Appendix D

Responses to Comments

Part I: Staff responses to written comments submitted in response to March 2014 draft Staff Report and proposed Basin Plan amendment

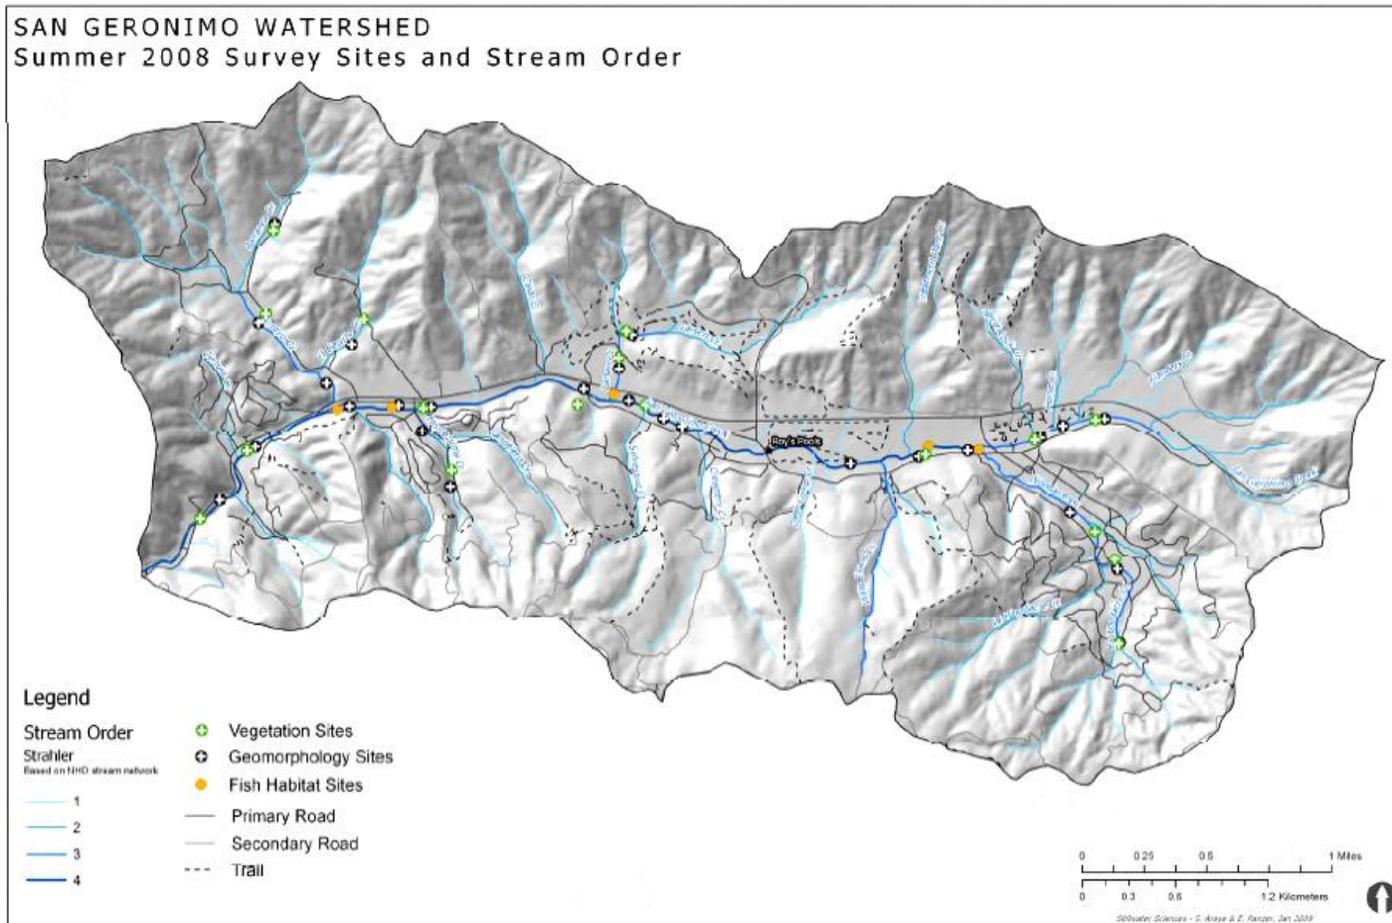
Comment 3.3: It would be most helpful to visually and verbally distinguish the specific land boundaries of where: the San Geronimo Creek Watershed begins and end; and Lagunitas Creek Watershed begins and end. This geographic information will greatly assist all West Marin property owners in understanding where these watersheds begin/end.

The *San Geronimo Valley Enhancement Plan* (Stillwater Sciences, 2009) includes several figures/maps that show the land area boundaries for the San Geronimo Creek watershed. Included below is Figure 2.2 from that report that overlays major roads, trails, and large channels on top of a shaded relief map.

In words, we provide the following description of the boundaries of the San Geronimo Creek watershed: "San Geronimo Creek begins in the headwaters of Woodacre Creek and the North Fork of San Geronimo Creek. Its major tributaries include Woodacre Creek, Larsen Creek, and Arroyo Creek. It continues downstream to the confluence of San Geronimo Creek with Lagunitas Creek, approximately at the Shafter Bridge." Adjacent watersheds include San Anselmo Creek, upper Nicasio Creek, and the upper Lagunitas Creek/Kent Lake watershed.

Figure 2.1 in the Staff Report (Water Board, 2014) shows the Lagunitas Creek sediment TMDL project area, outlined in yellow. We also include it here.
